UNITED STATES PATENT AND TRADEMARK OFFICE

APPLICATION NO.	FILING DATE	FIRST NAMED INVENTOR	ATTORNEY DOCKET NO.	CONFIRMATION NO.
10/023,082	12/17/2001	Ichiro Fujieda	15168	7772
23389	7590	03/01/2004	EXAMINER	
SCULLY SCOTT MURPHY & PRESSER, PC 400 GARDEN CITY PLAZA GARDEN CITY, NY 11530			MACCHIAROLO, PETER J	
			ART UNIT	PAPER NUMBER
			2875	
DATE MAILED: 03/01/2004

Office Action Summary	Application No. 10/023,082	Applicant(s) FUJIEDA ET AL.	
	Examiner Peter J Macchiarolo	Art Unit 2875

DETAILED ACTION

FIG. 1

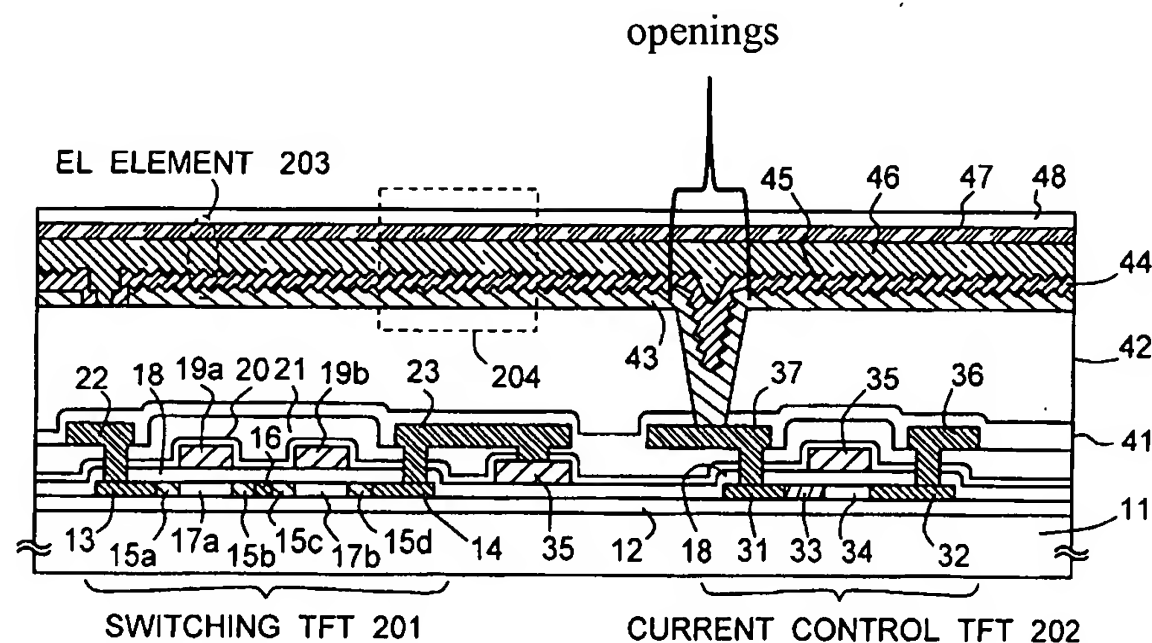
9. As broadly as claimed, Yamazaki anticipates claims 1 and 6. Yamazaki discloses in figure 1, a light emitting device having thin film transistor (TFT, 202) on an insulating base material (11); and above the TFT, a luminous section including a luminous material layer (46) and electrode layers (43, 44) supplying current to the luminous material layer; and a plurality of openings (below) in a predetermined pattern on a second insulating base material (42) and at least one material placed above the insulating base material (42) and below the luminous material layer, which is made of organic materials.¹

10. In regards to claims 4 and 9, Yamazaki discloses in figure 1, a light emitting device comprising a TFT (202) on an insulating base material (11); and stacked above the TFT, at least an insulating layer (42); a first electrode layer (47) to supply current to an organic luminous material layer (46), a second electrode layer (43), wherein the first electrode layer being made of

a transparent material, and the second electrode layer being made of a reflecting material,² a plurality of openings (above) on one of the insulating materials (42) and at least one material (44) placed above the insulating base material and below the luminous material layer, and the first electrode layer on convex sections of the insulating layer.

FIG. 1

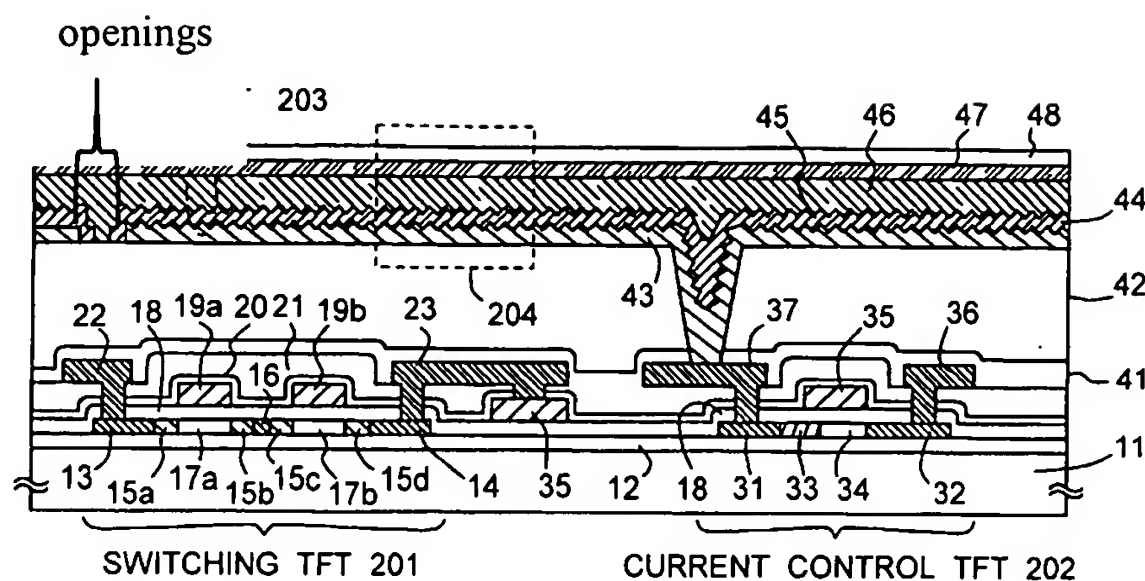
12. As broadly as claimed, Yamazaki teaches the limitations of claims 2 and 7. Yamazaki discloses in figure 1, a light emitting device comprising; stacked above an insulating base material (11), a first electrode layer (44) to supply current to an organic luminous material layer (46), and a second electrode layer (47) to supply current to the luminous material layer, a plurality of openings in a predetermined pattern (below) on the first electrode layer, and concavities and convexities formed on the luminous material layer and on the other electrode layer.

13. Yamazaki is silent to the first electrode being transparent.

14. However, it would have been an obvious matter of design choice to construct the first electrode from a transparent material, since Applicant has not adequately disclosed any testing or analytical data which establishes criticality for this modification, or recites any specific advantage the invention benefits from over the prior art from this modification. It appears that Yamazaki's light emitting device would perform equally well when constructing the first electrode from a transparent material.

18. In regards to claims 3 and 8, Yamazaki discloses in figures 1 and 3A, a light emitting device comprising; stacked above an insulating base material, at least a first electrode layer (47) to supply current to a luminous material layer (46), and a second electrode layer (44) to supply current to the luminous material layer, and the first electrode layer is made of a transparent material; the first electrode layer in plan view having a comb shape, and the luminous material layer, which is made of organic material, and the other electrode layer stacked on the electrode layer made of the transparent material are in the shape of concavities and convexities in side view.

19. Yamazaki is silent to the comb shape partly having circular regions.

20. However, it would have been an obvious matter of design choice to construct Yamazaki's comb shape partly having circular regions, since Applicant has not adequately disclosed any testing or analytical data which establishes criticality for these modifications, or clearly recites any specific advantage the invention benefits from over the prior art from this modification. It appears that Yamazaki comb shape would perform equally well when having circular regions.
